Docket Item #6  
BAR CASE #2006-0061

BAR Meeting  
April 18, 2007

**ISSUE:** Addition  
**APPLICANT:** David Canfield by Linda Serabian  
**LOCATION:** 219 North Royal Street  
**ZONE:** RM/Residential

Figure 1 - Proposed rear

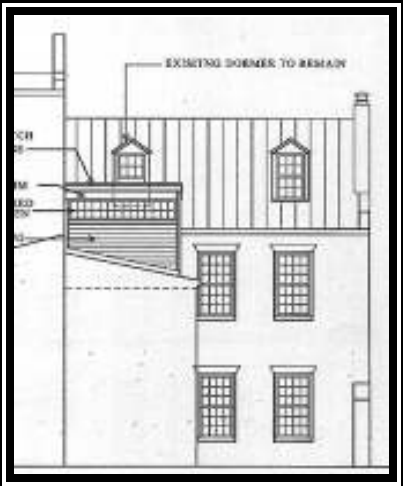
The proposed addition is situated above a frame infill section at the rear of the house and extends over onto the adjacent roof of the historic main block of the house to the west. While the addition carries the line of the infill addition upward to a third story, staff believes that the addition represents an unacceptable intrusion into the composition of this important early 19<sup>th</sup> century residence. While staff is cognizant that the addition will be minimally visible down a rear alley when viewed from the east from North Fairfax Street, staff is of the belief that the late 18<sup>th</sup> and early 19<sup>th</sup> century patrimony of the historic district is so fragile and valuable that it needs to be carefully shepherded lest so many compromises be made that the intrinsic character of the early architecture of the city is irretrievably lost. Thus, in the case of this addition, staff believes that the basic third story *patri* is inimical to the preservation of the residence both by incorporating portions of the roof of the main historic block as well as setting a third story above the existing rear addition. Staff is also concerned about the precedent that the Board would set by approving a third story that incorporates sections of historic residential buildings. Because of these factors, staff recommends denial of the proposed addition.

Built between 1811 & 1814 by James McGuire (Cox, p. 151). The windows should be wood clad, not aluminum. The proposed window design should be reconsidered. In proposed elevation

1, removing the dormer window and installing the indicated fixed windows would not be appropriate for this early 19<sup>th</sup> c. house.
